UNITED STATES ENVIRONMENTAL PROTECTION AGENCY

November 21, 2018

Summary of request: On June 29, 2018, the PRPs (City of Tomah and International Paper) proposed to modify the current OU2 groundwater monitoring program based on hydrogeological data and groundwater quality trends since 2000. They propose to abandon five monitoring wells: MW9A, MW9B, MW9C, MW13 A, MW13 B and adjust sampling of MW11 B to every five years. The wells network is part of the Remedy in the 2003 Record of Decision for OU2.

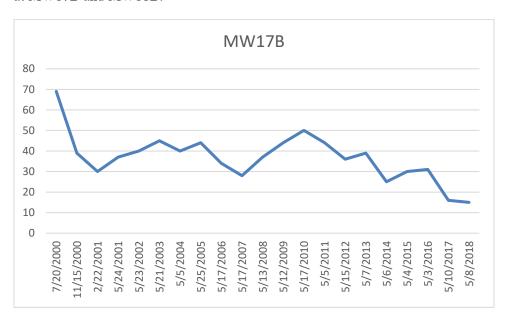
- MW9A is only used for hydrologic monitoring as long-term sampling indicated more than 50% nondetect. Based on chemical data and hydrologic flowpaths, it is acceptable to abandon this well.
- 2. MW9B is sampled biennially and shows a decreasing trend. MW-11B is sampled biennially and has been nondetect and will continue to serve as a sentry well. Below is the trend data for MW9B.

Upgradient well MW17B has followed along similar decreasing trend lines. It is okay to temporarily remove MW9B from the monitoring well program as there are enough data to support defining the plume at MW17B and MW11B.

When MW17B achieves the RAOs for vinyl chloride, MW9B should be resampled to determine if it meets the RAOs before being abandoned. If MW9B does not meet the RAOs, then the PRPs, WDNR, and EPA can determine the appropriate monitoring frequency to demonstrate compliance with the RAOs in the 2003 ROD.

MW13A (blue) and MW13B (orange).

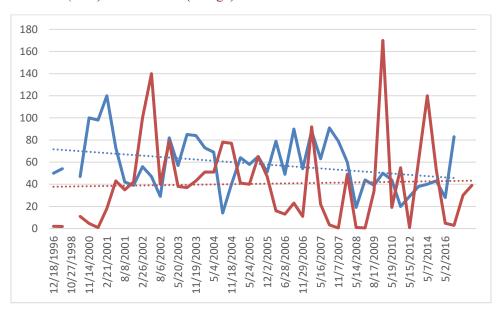
- 3. MW9C is sampled biennially and has been 100% non-detect in VC. It is agreed that this well can also be abandoned.
- 4. MW13A/MW13B are sampled annually and shows no trend and the most recent VC results were increases at 83 ug/L and 30 ug/L, respectively. PRP wants to abandon it because MW-21 and

MW14 nest already serve as sentry points for the plume expansion. Please note that the plume mass itself needs also to be understood and lines of evidence to support the degradation are needed for MNA analysis. The stability of the plume at these two wells will prolong the projected cleanup duration and this timeline needs to be understood. EPA does not recommend abandoning these wells and recommend continued annual sampling.
